# Cambridge Crossing

## *Design Review Application – Parcel Q1*

Reference: Cambridge Crossing Parcel Q1 Design Review  
PB#179  
Cambridge, Massachusetts  
B+T Project No. 2084.02

North Elevation - Proposed

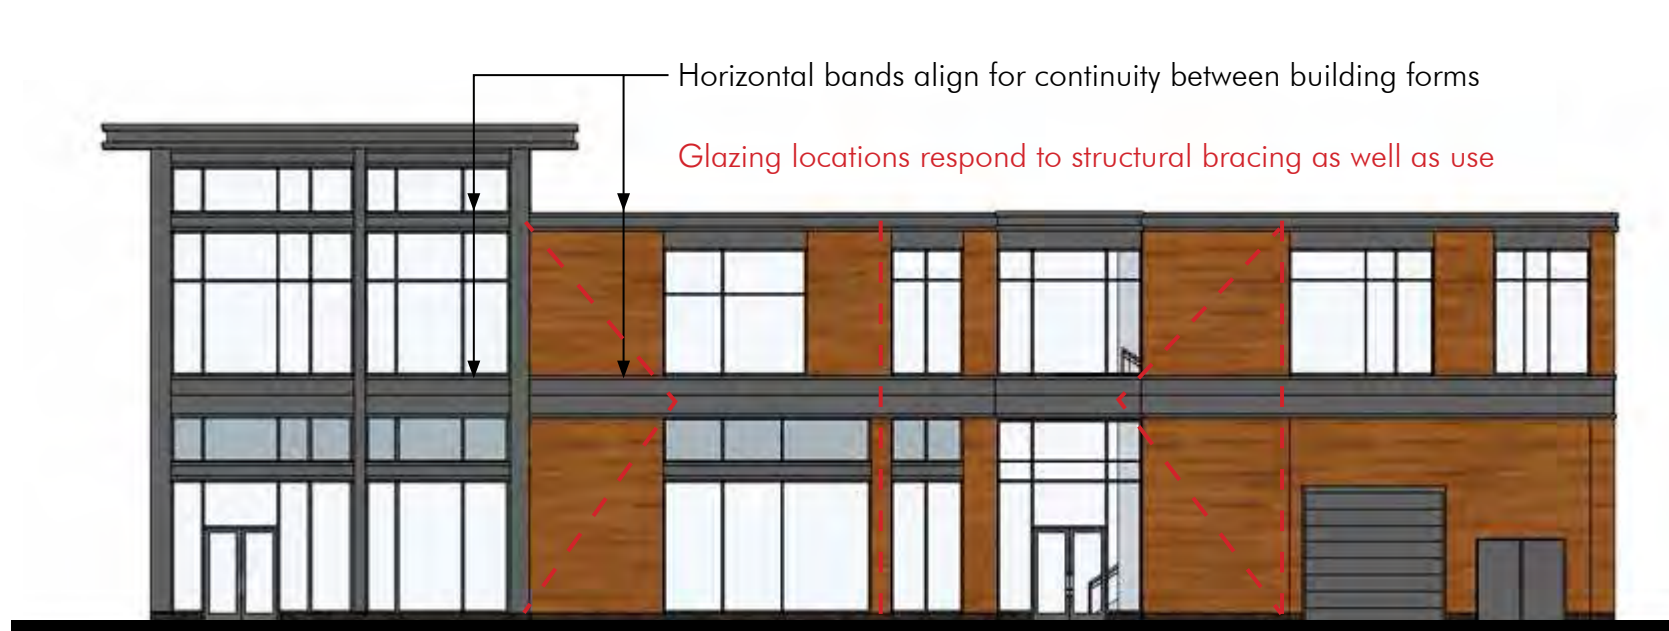
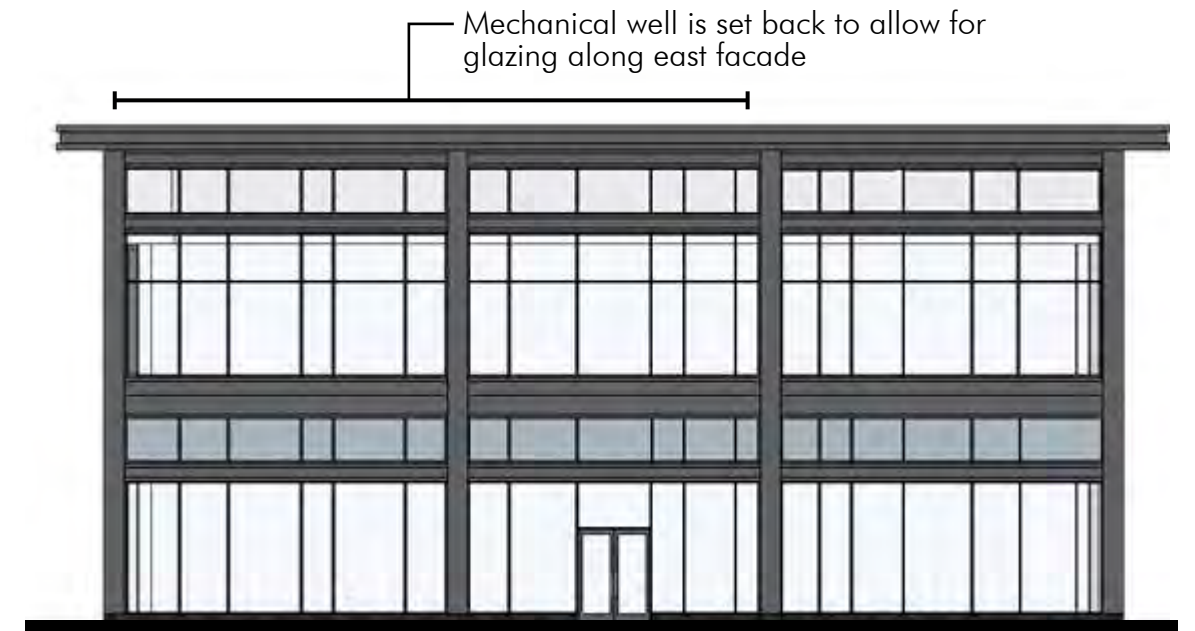
page 157 & 176 - PB #179 Meeting Minutes	"I think the roof cantilever has to extend around both sides to in line with the façade down below" .... "So I'll be clear, I want to see the roof where the pavilion stick out the same amount on the three sides and maybe turn it around to the fourth side."	Roof extends 6' on the east façade (on North First Street) and 4' on the other 3 sides, wrapping around the west side of the "glass pavilion".	✓
page 157 - PB #179 Meeting Minutes	"I think the louvers need to be broken up in the same way that the windows in the right-hand end are articulated in that fashion and they shouldn't -- it should leave the frame being articulate in the place that they are."	Frame is articulated similarly throughout the glass pavilion. Mechanical well has been pulled away from the façade to allow for consistent glass & frame articulation across all facades.	✓
page 160 - PB #179 Meeting Minutes	"like two buildings are colliding and the one on the right is sort of like the back of a building. "... "the building on the left has this really powerful hat, and the building on the right has like an eight-inch tall hat."	Roof wraps around all four sides of the glass pavilion. The vertical extension, which previously split the "two buildings," has been removed. Horizontal expression of low roof parapet aligns with horizontal band in glass pavilion, creating a consistent horizontal expression uniting the two building volumes.	✓

- Roof wraps around glass pavilion
- Glass pavilion extends north and south in plan
- Horizontal bands are continuous between glass pavilion and lower building
- Glass volume protrudes at office entry
- Revised treatment of louvers at top of glass pavilion
- Revised glazing sizing and alignment

# Outdoor Bicycle Parking at Parcel Q1 - Revised

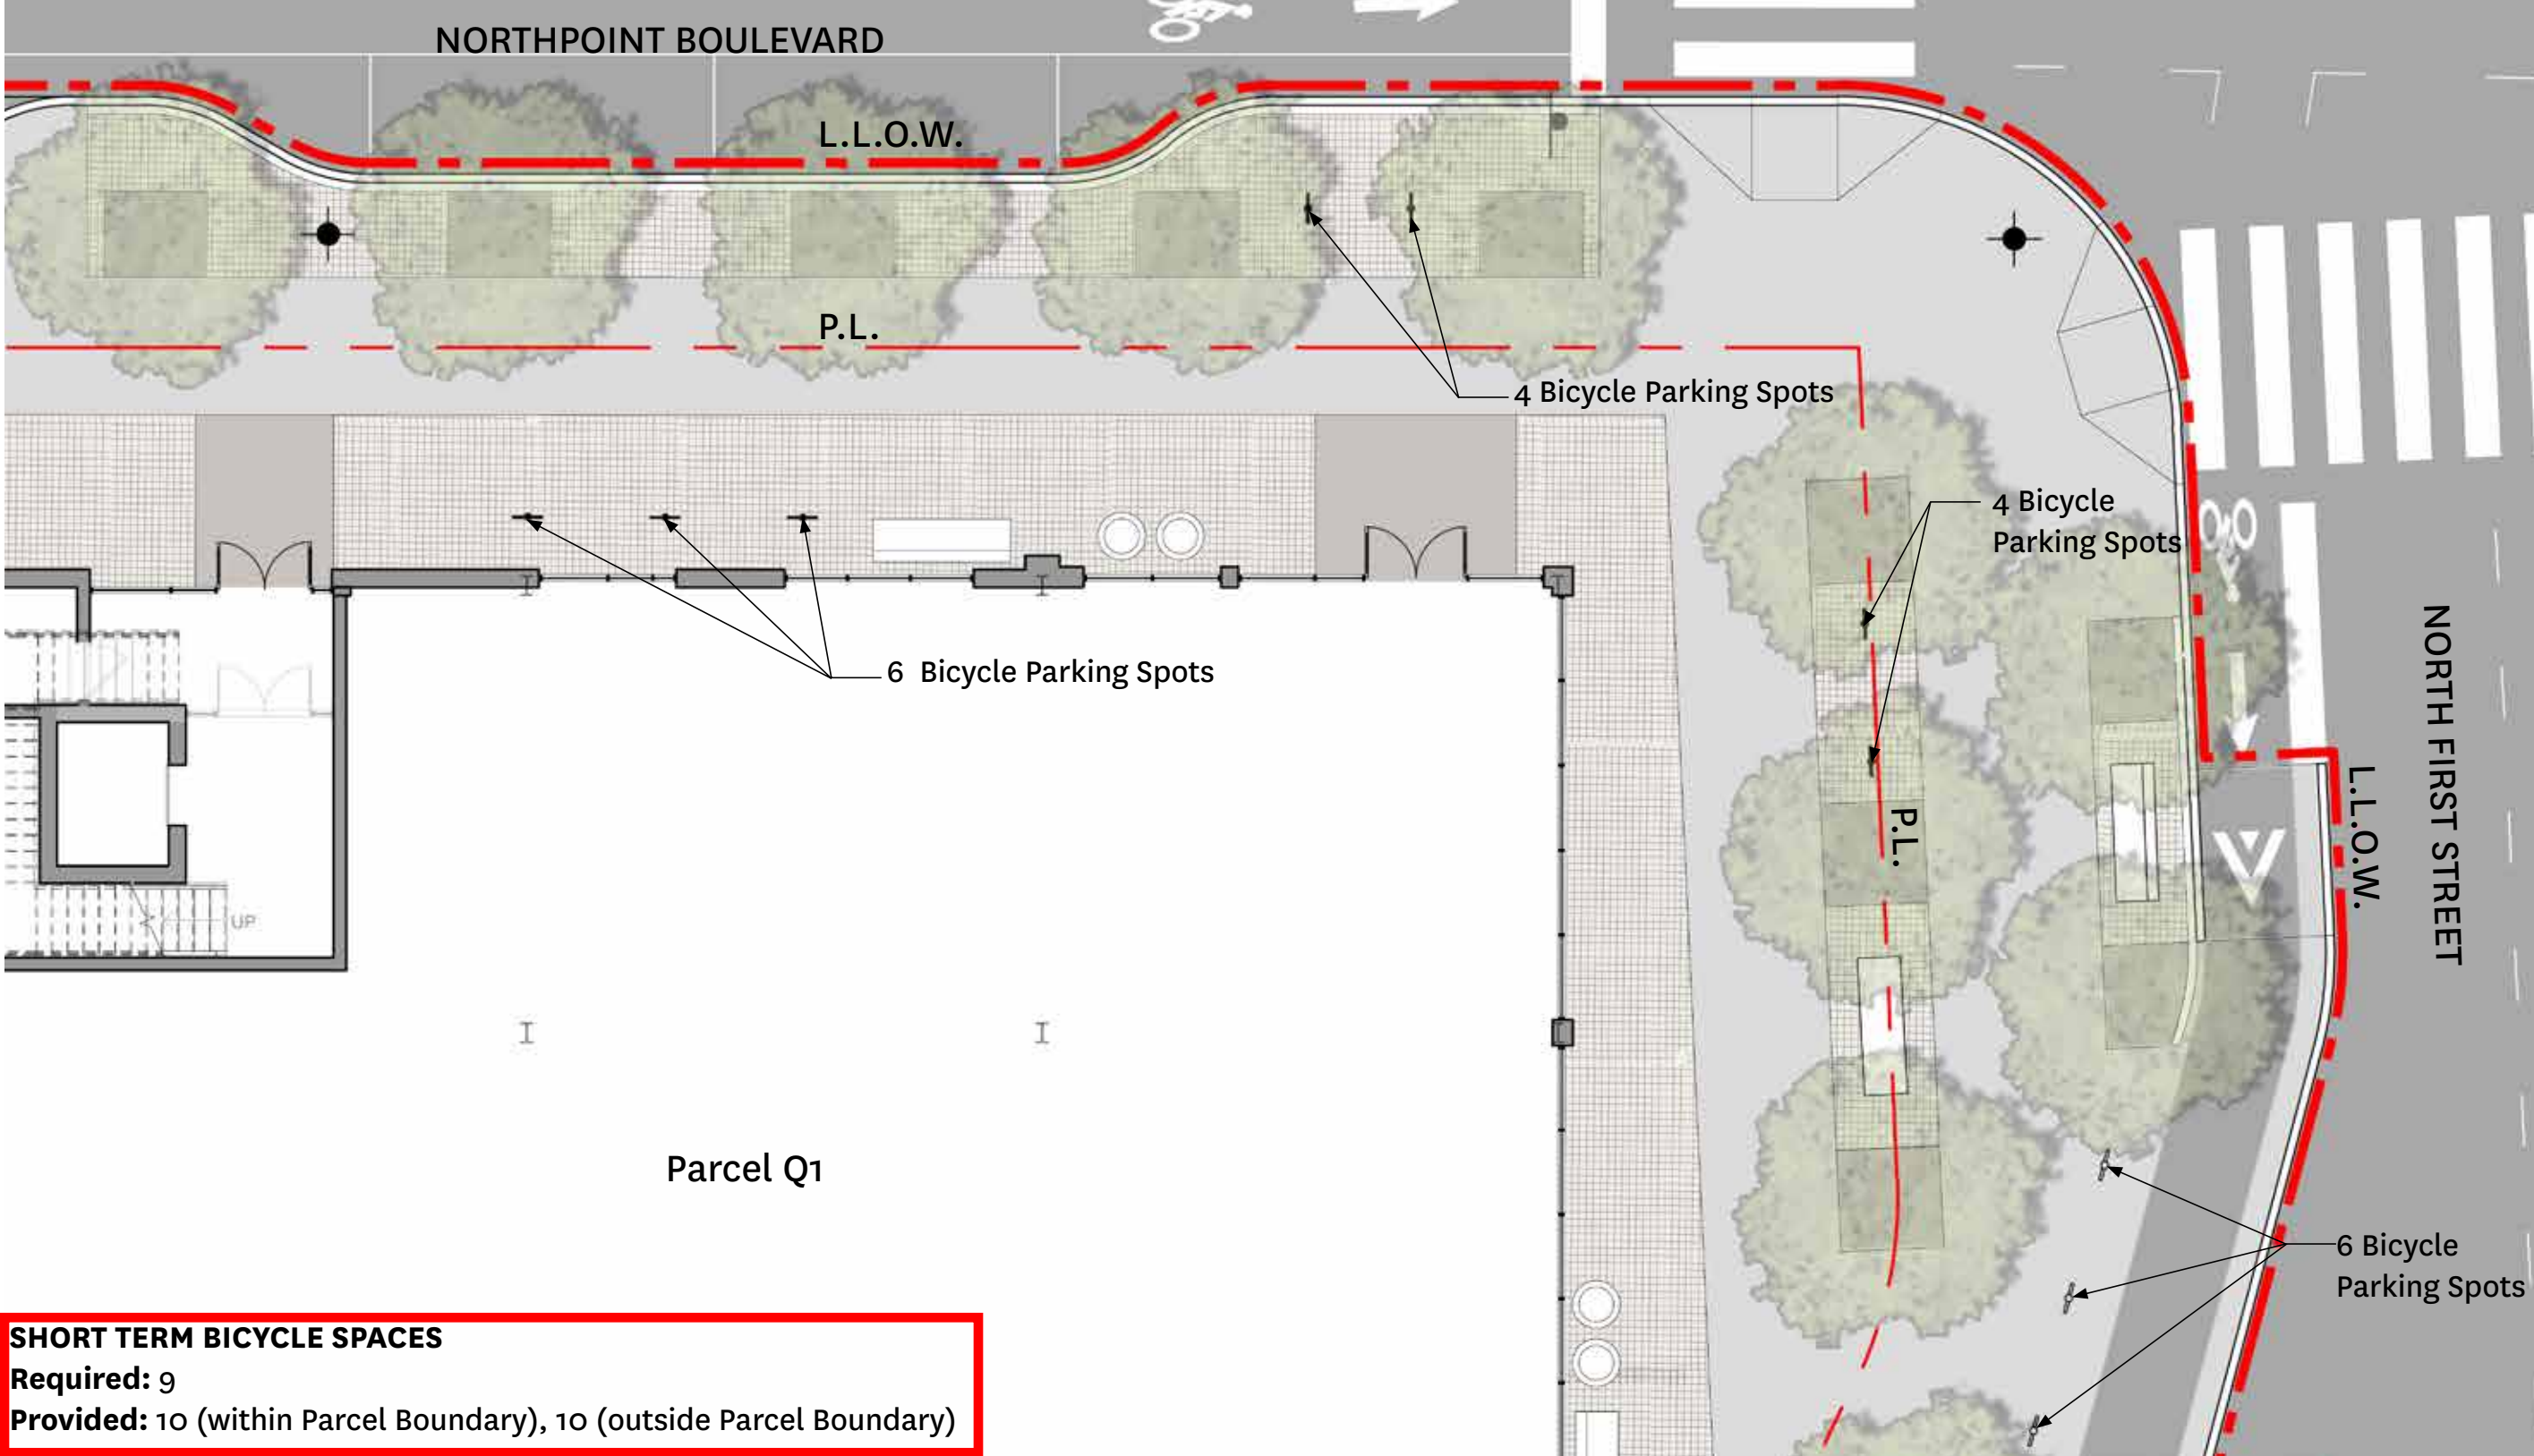
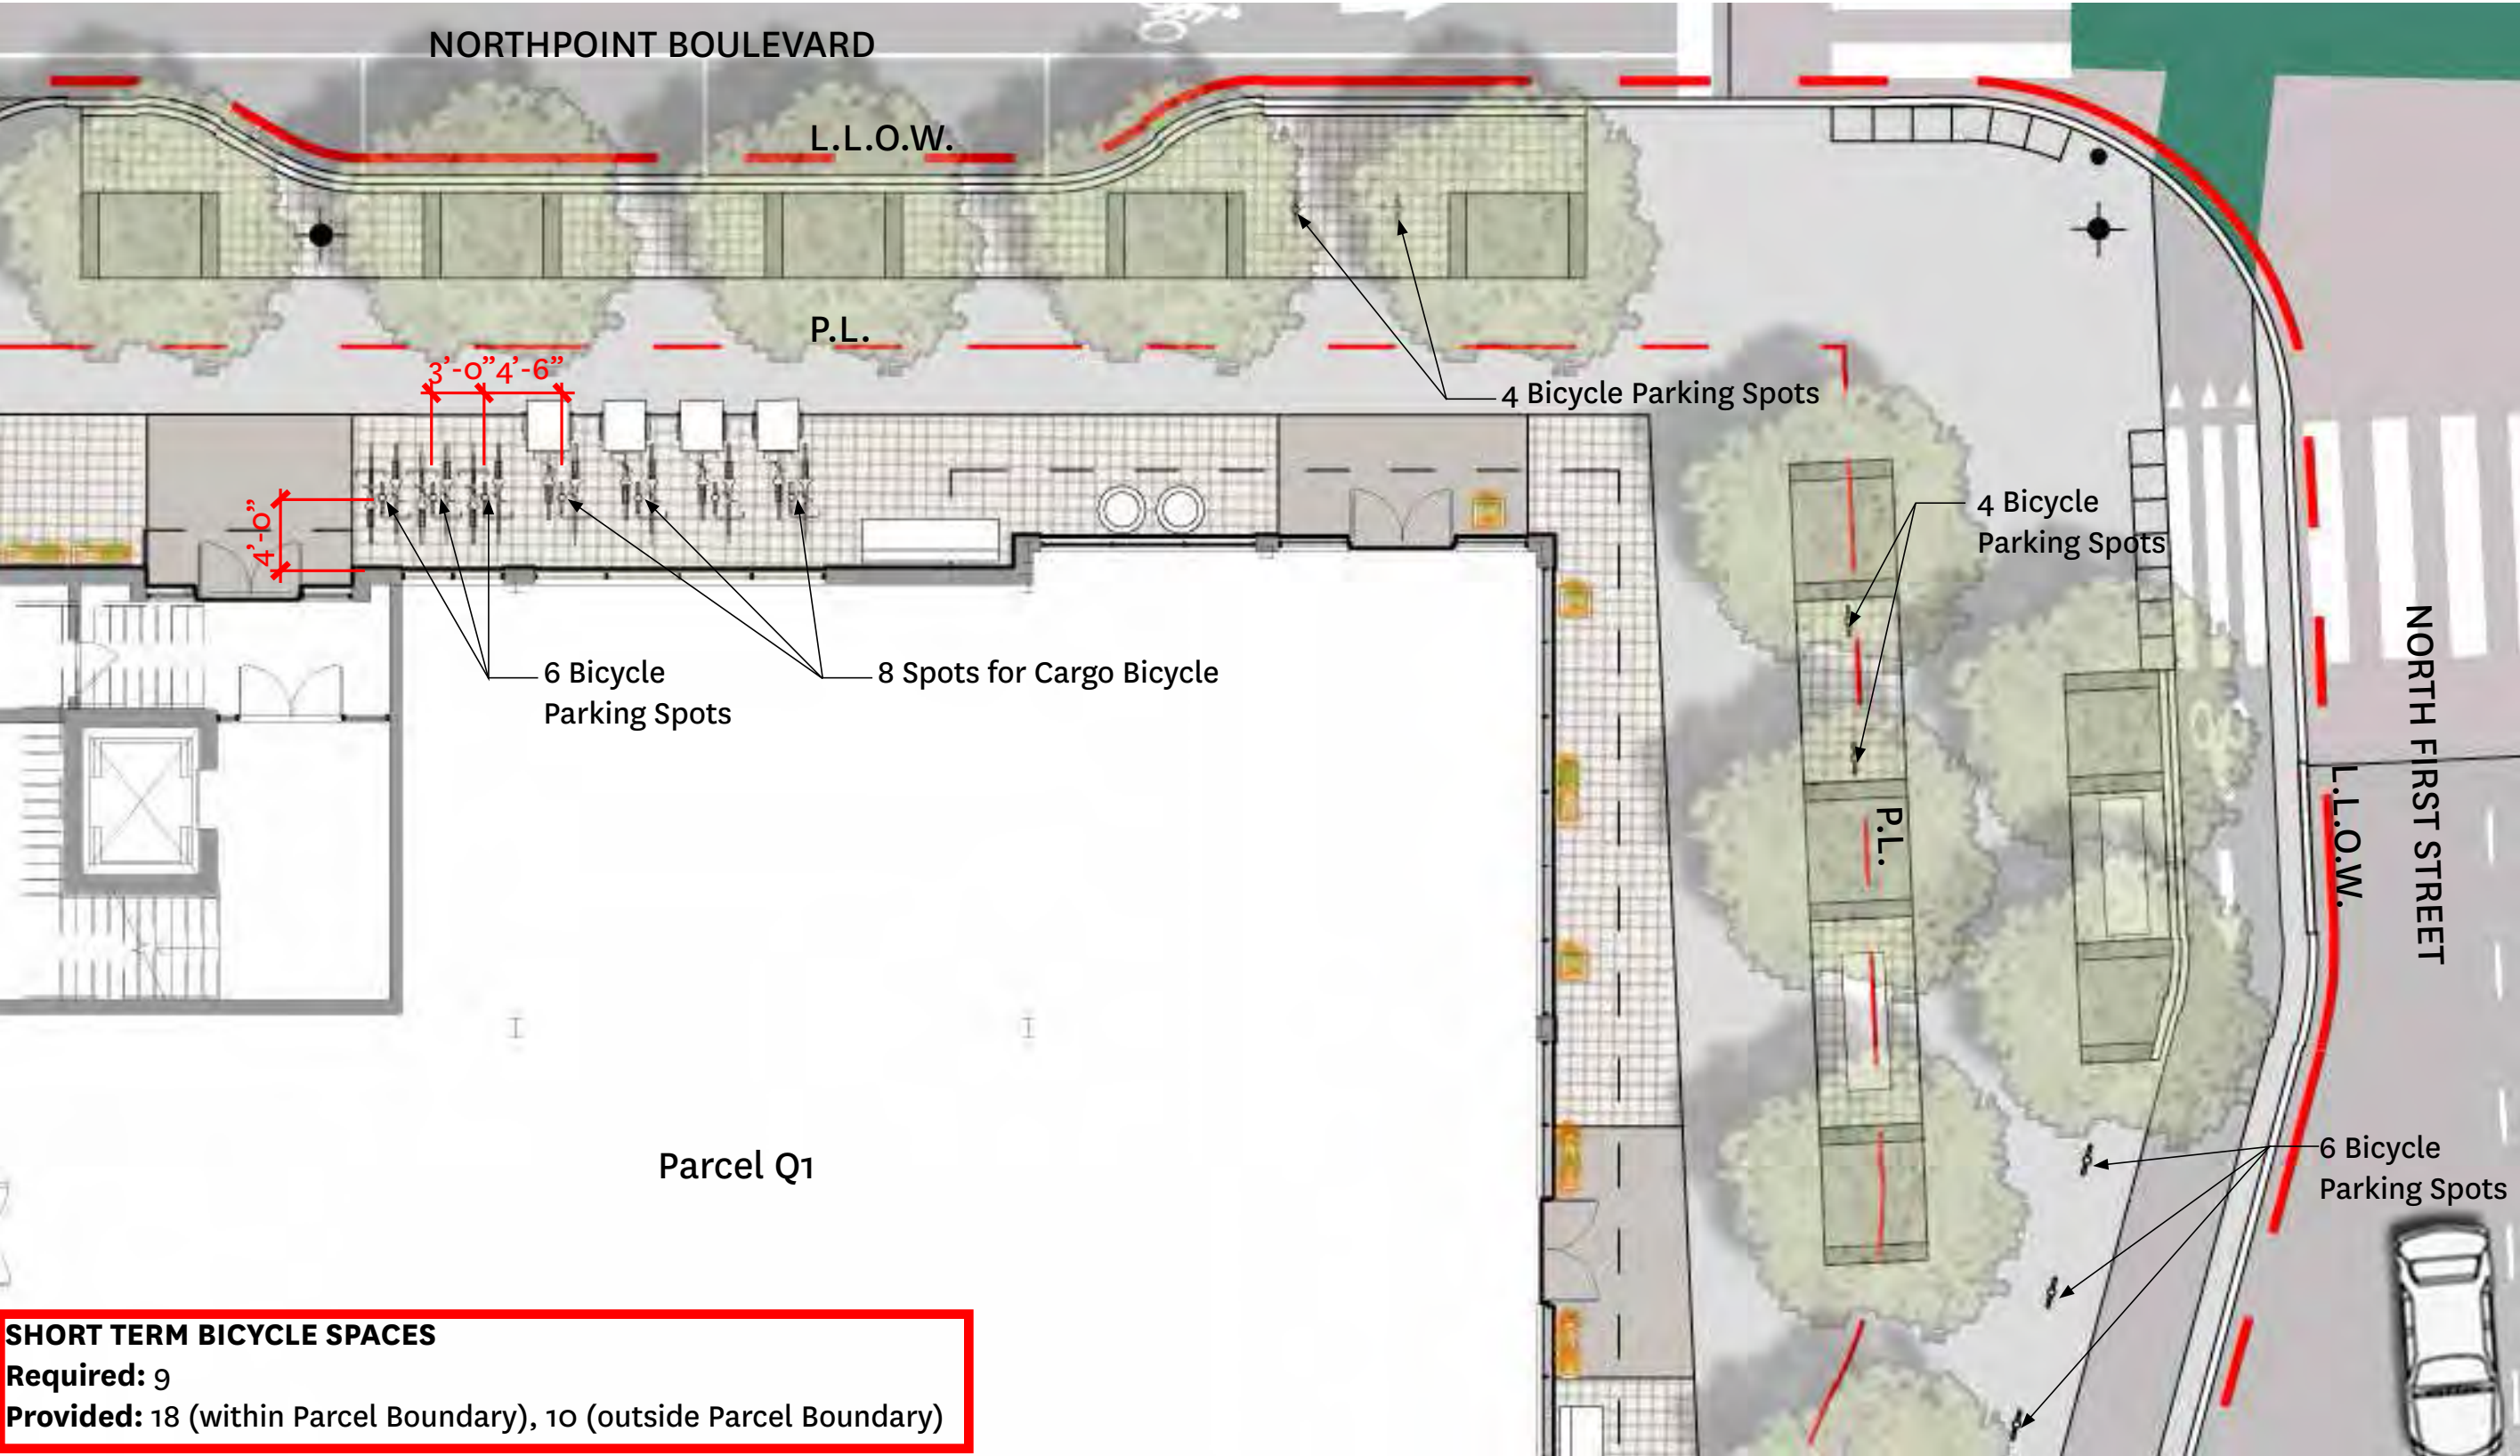
Page	Design Review Comments	Design Team Response	Check
page 154 - PB #179 Meeting Minutes	"So I think there need to be more bike racks, and they have to be thought about who's going to use them and where are they going to use them. That perhaps there could be some bike racks around basically on the back from this view that might be designated for employees, they would be close to the employee entrance".	MVVA increased the number of bike racks on NorthPoint Boulevard and introduced spaces for cargo bikes.	✓
page 154 - PB #179 Meeting Minutes	"Also you have some wide sidewalks that I'm glad you're planting trees, but there is still no understory planting, no real welcoming place. I hate to say this again but benches, plants, color, something".	MVVA introduced moveble planters in a variety of sizes to increase the planting in this area. On the west façade, tensile cables on the building will support flowering climbing vines to add color.	✓

**SHORT TERM BICYCLE SPACES**  
**Required: 9**  
**Provided: 10 (within Parcel Boundary), 10 (outside Parcel Boundary)**
